Case 22-01D

VALVE BOX INSTALLATION
AND GRADE ADJUSTMENT

DEBRIS CAP INSTALLATION

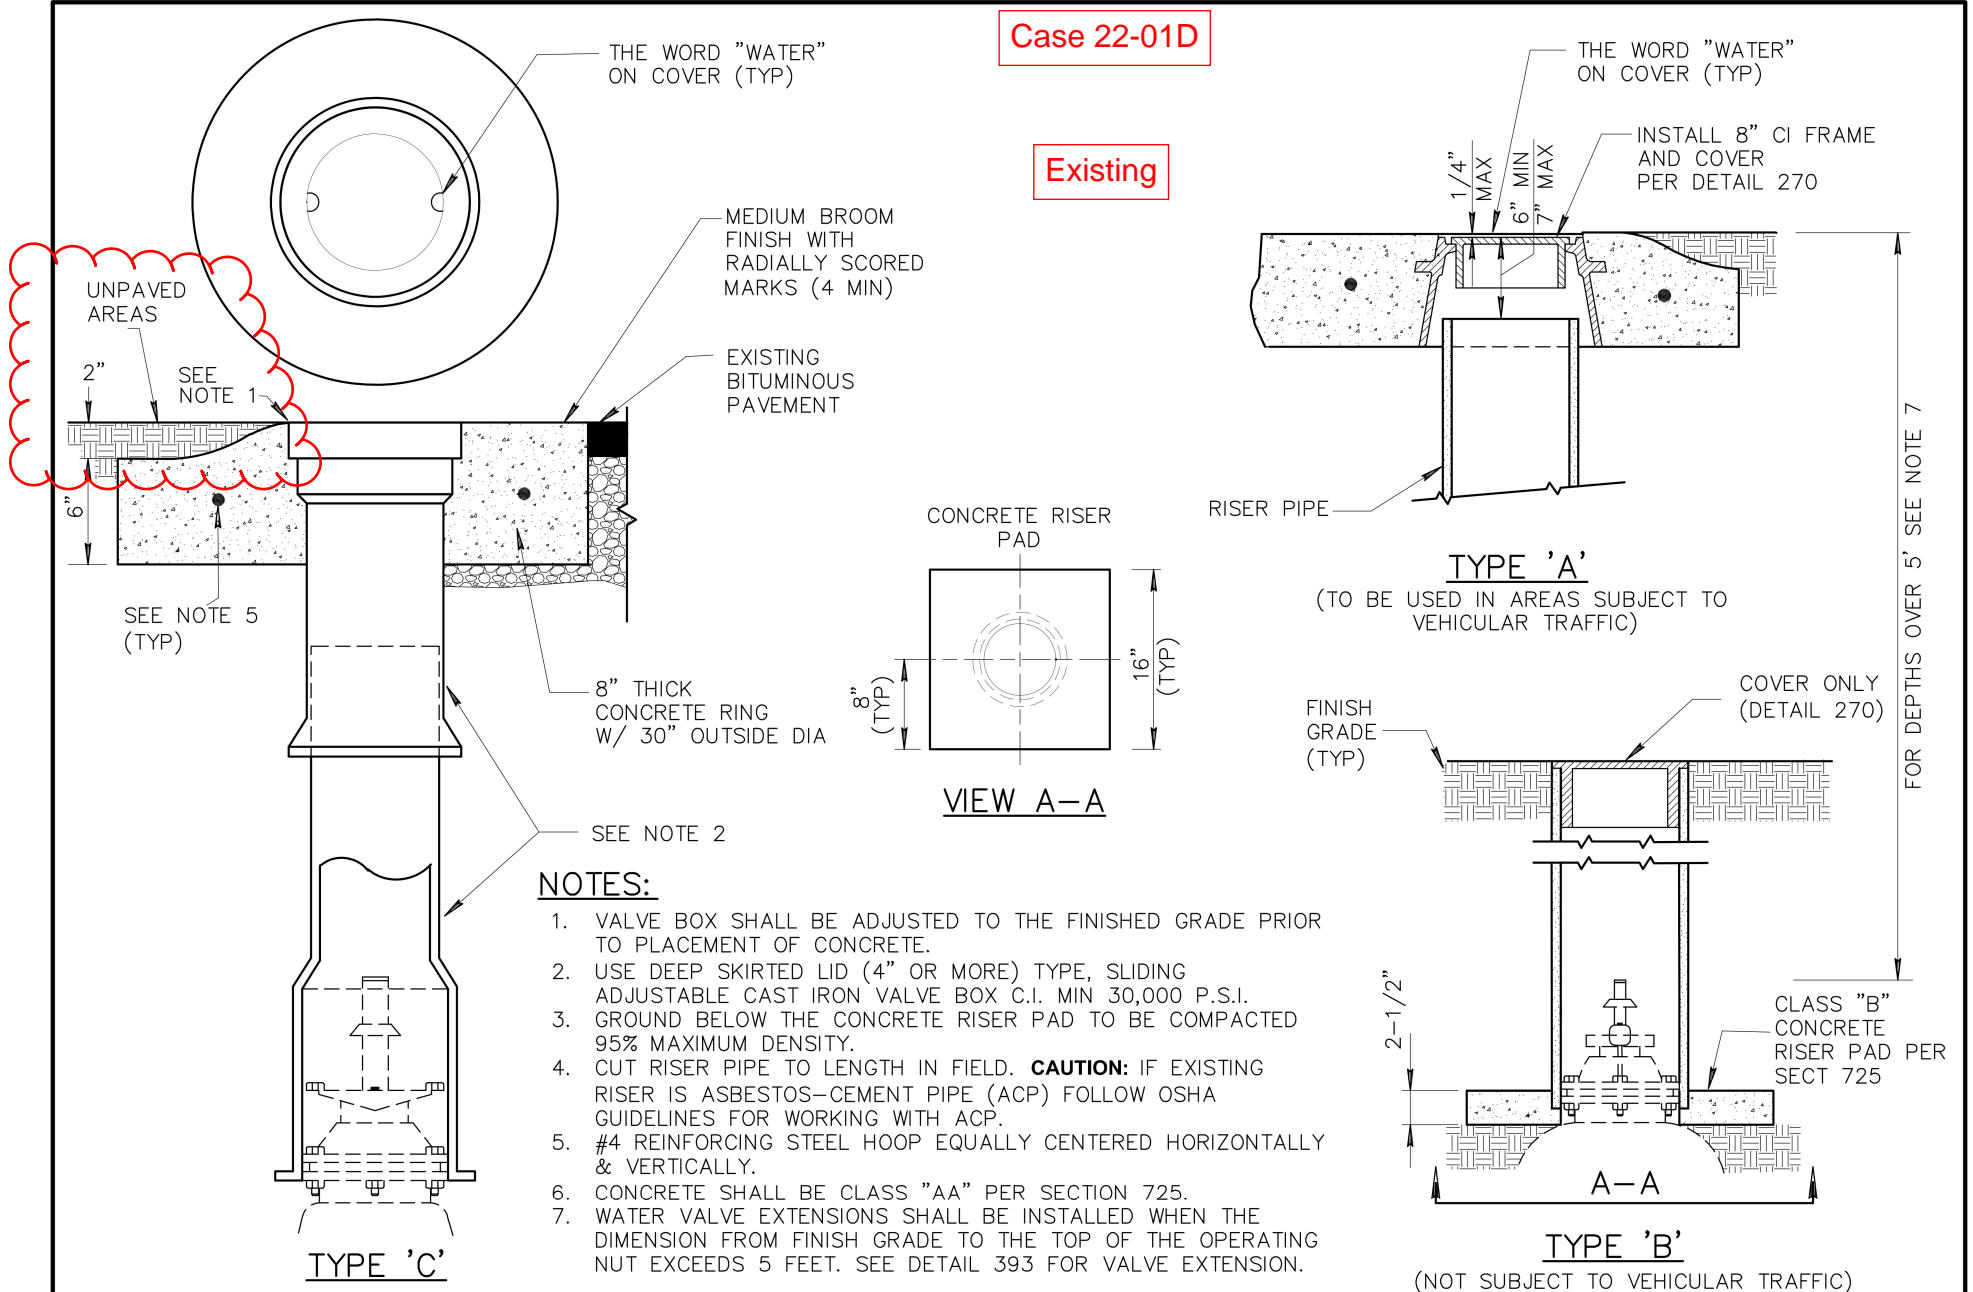
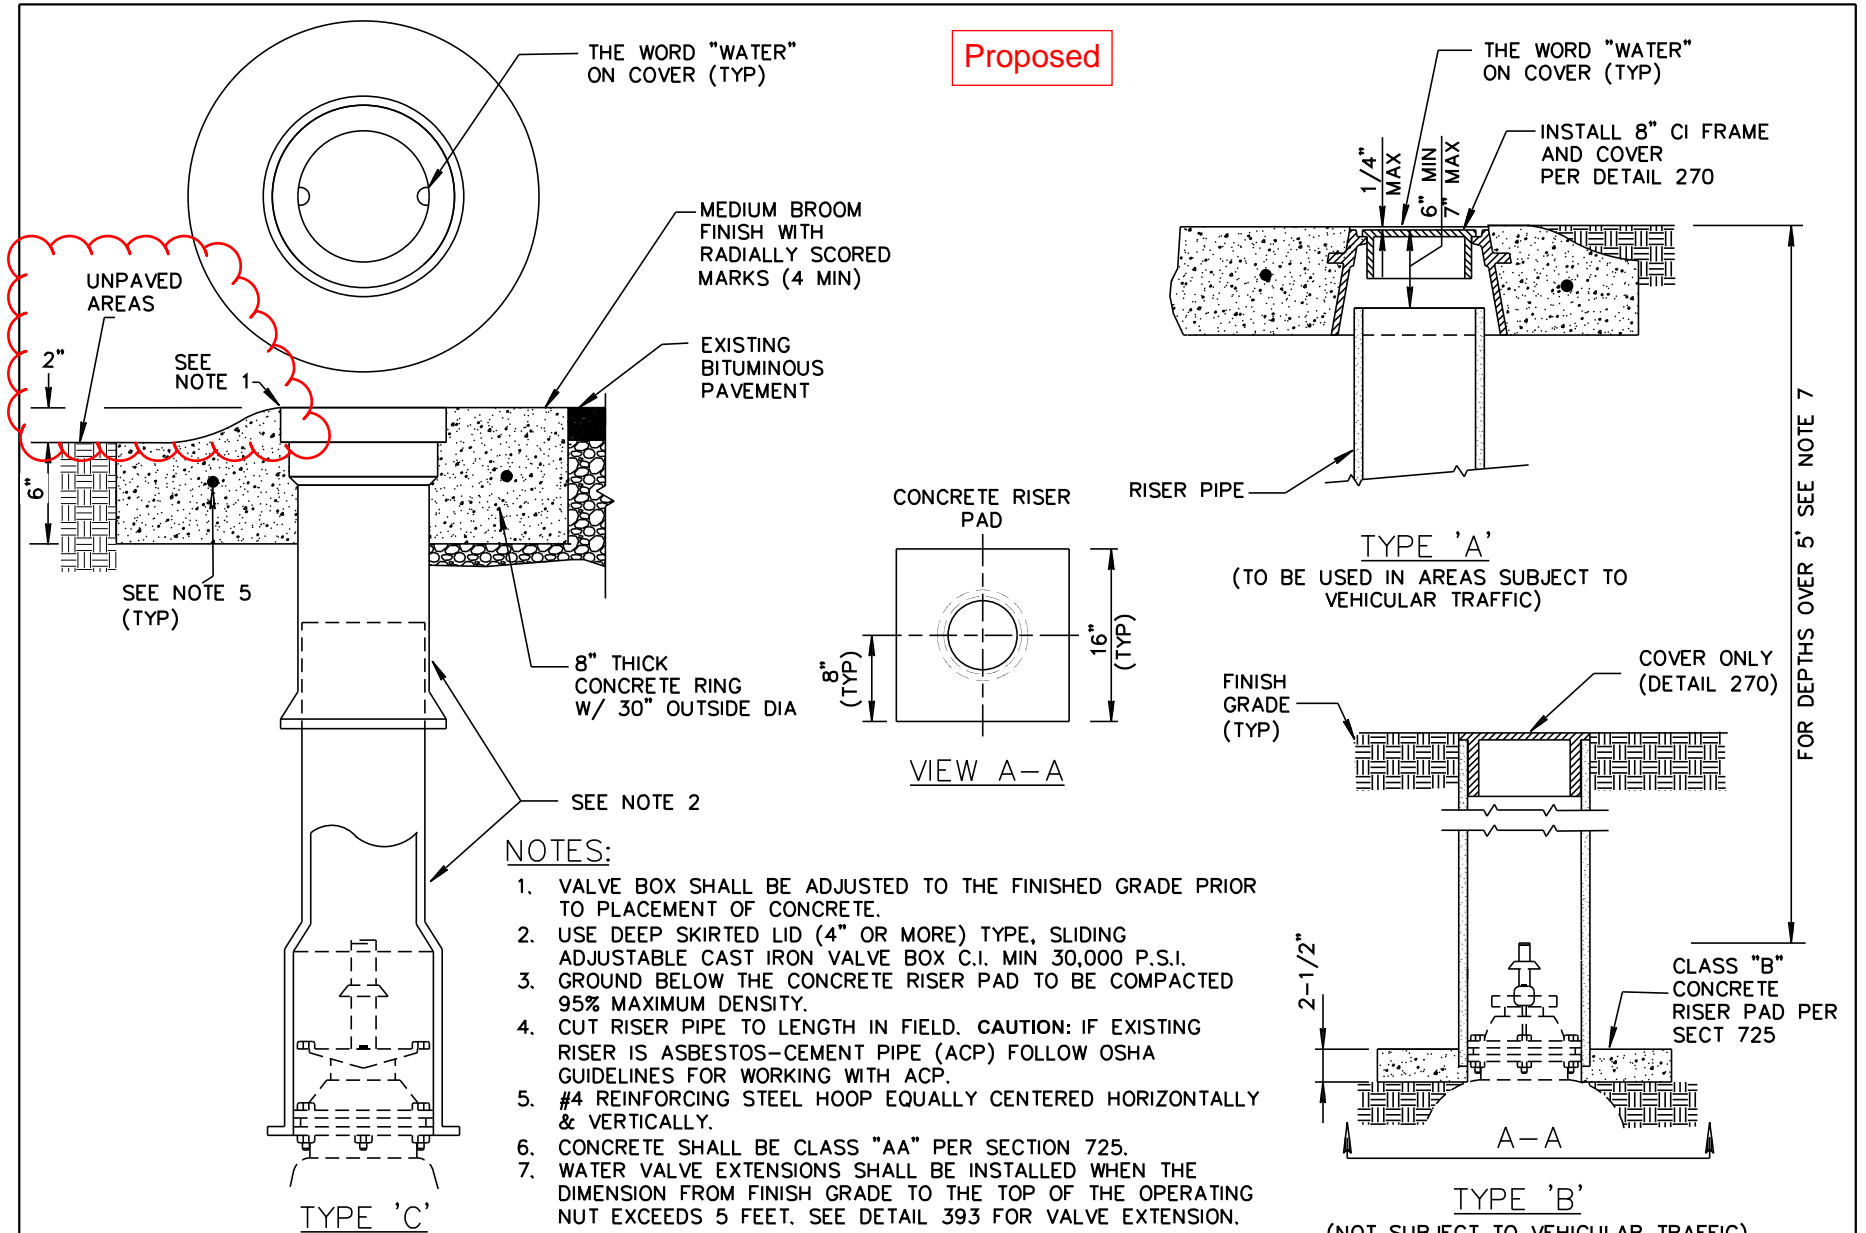
Existing

Proposed

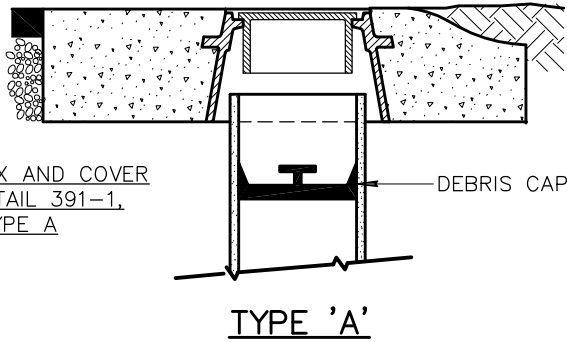
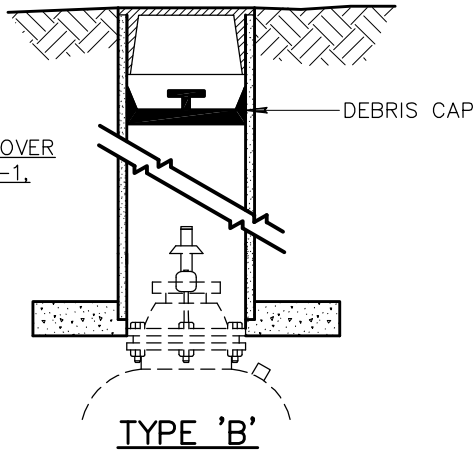
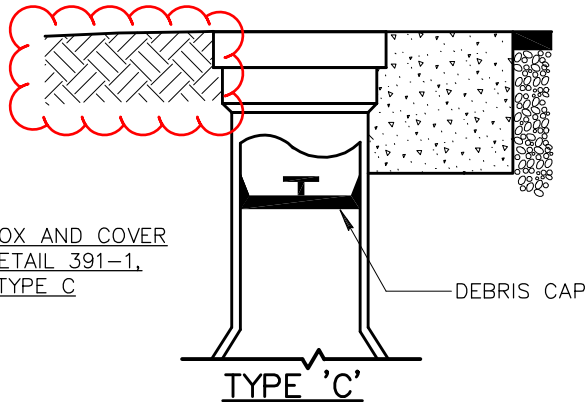
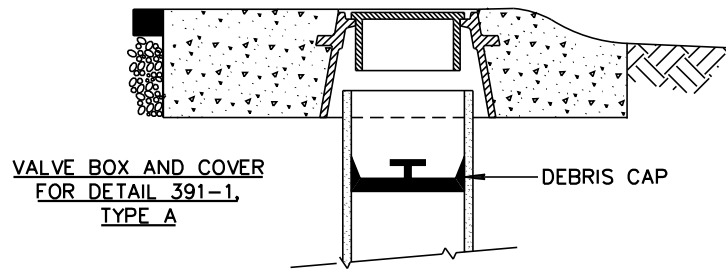
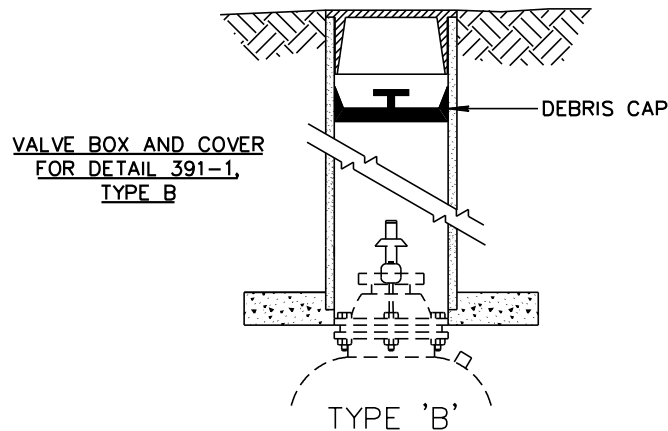
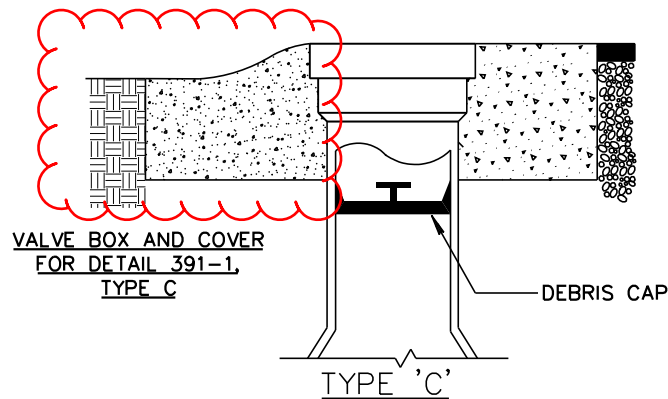
Existing

Proposed
